**ATTACHMENT 3**  
**WALKDOWN CHECKLISTS**

**Seismic Walkdown Checklist (SWC)**

Equipment ID No.: 1PNL1C10

Project: CCNPP 1 SWEL

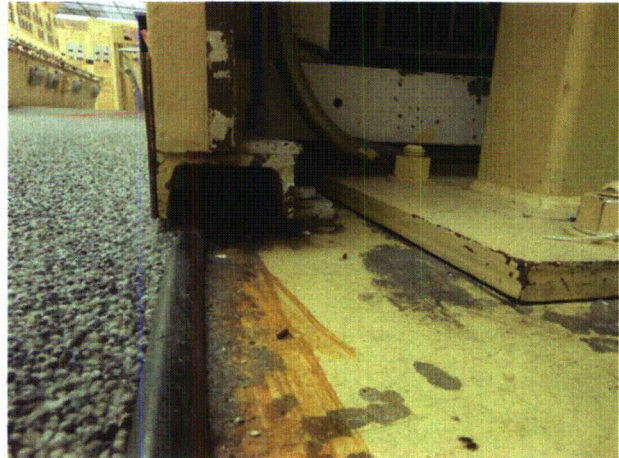
5. Is the anchorage configuration consistent with plant documentation? (Note: This question only applies if the item is one of the 50% for which an anchorage configuration verification is required.) No  
*Anchorage used details that are not shown on the drawing, but are judged to be equivalent. See as-built on drawing G1992 SH0004 Rev. 9. CR-2012-009725*

6. Based on the above anchorage evaluations, is the anchorage free of potentially adverse seismic conditions? Yes  
*The anchorage detail deviations do not adversely affect the cabinet's anchorage, therefore there is no potential seismic*

*Metrological cabinet is in close proximity to the cabinets, tipping over may be a concern. The Met. cabinet dimension are 24"x29"x58"H and estimated to weigh less than 200#.*

*Dmax (tip over) = 0.15", Theta max = 0.04 Deg.*

*Actual tipping angle, alpha = tan<sup>-1</sup>(12/39) = 17 Deg >> Theta max, therefore the Met. Cabinet will not tip over.*

*Craft back board may fall on back of panel or may strike strip recorder.*

*Recommend moving it. CR-2012-008387*

1PNL1C18A 8-14-12 131

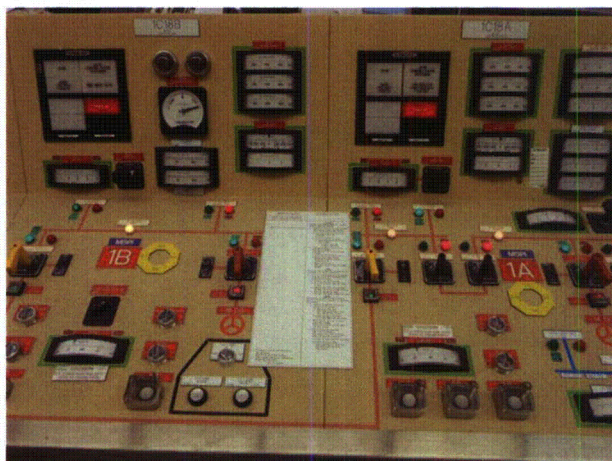
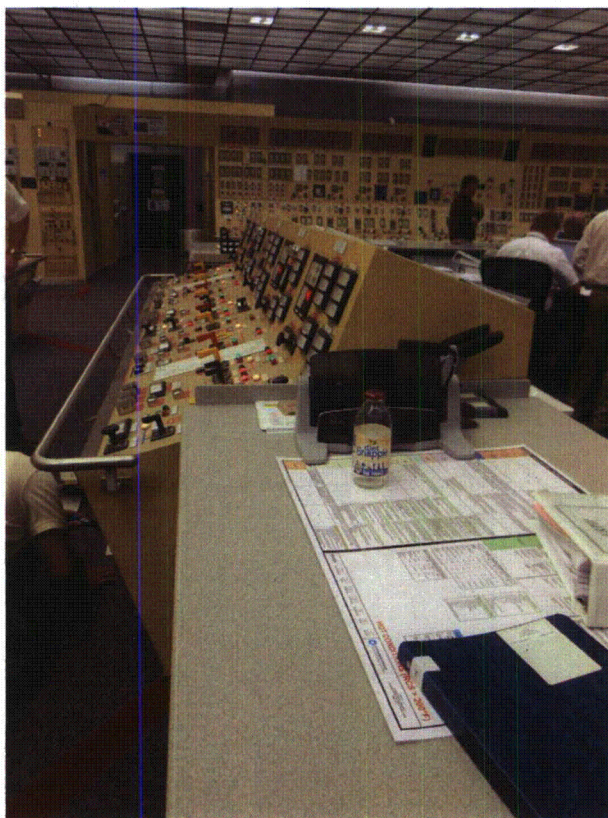
*SWE opened the front of the cabinet lineup and only C18A of the rear, because there are anchored bookcase that need to be unanchored and moved out of the way. The only anchorage observed was one ½" CEA in the front and rear of C18A and one in the rear of C18B. No other anchor bolts were observed due to interferences with cables and the inaccessibility of the rear.*

*The anchorage is not consistent with SP-0715. SP-0715 shows expansion anchors on the sides of the cabinets not along the front or rear. However, SP-0715 does not indicate the anchor bolt size. CR-2012-009708*

1PNL1C62B 8-13-12 127

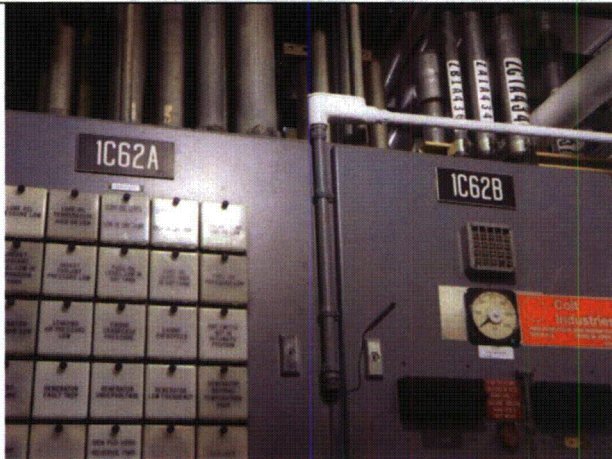
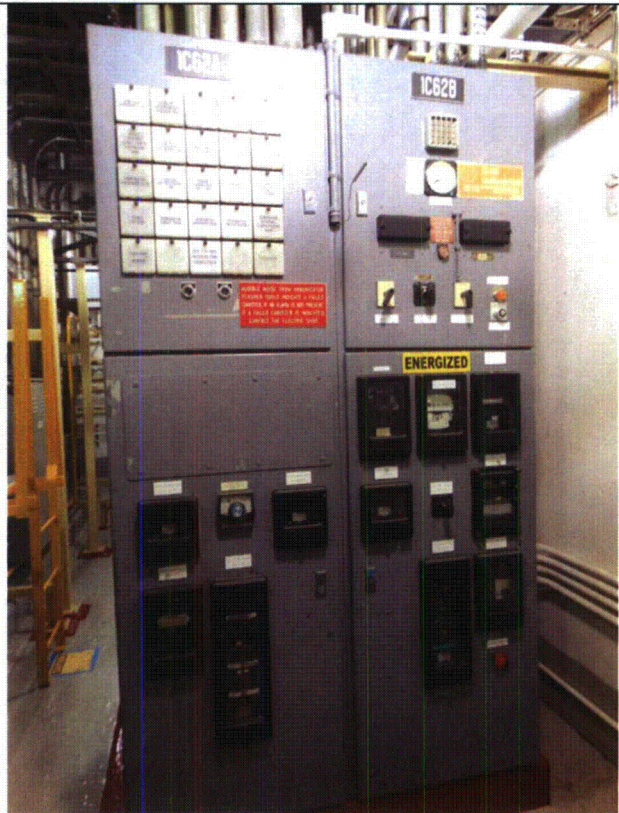
2. Is the anchorage free of bent, broken, missing or loose hardware? No  
*Anchorage is inaccessible.*

*Panel is in contact with conduit. Need to determine if this condition is seismically acceptable. CR-2012-009670*

*Cabinet is inaccessible for internal inspection.*
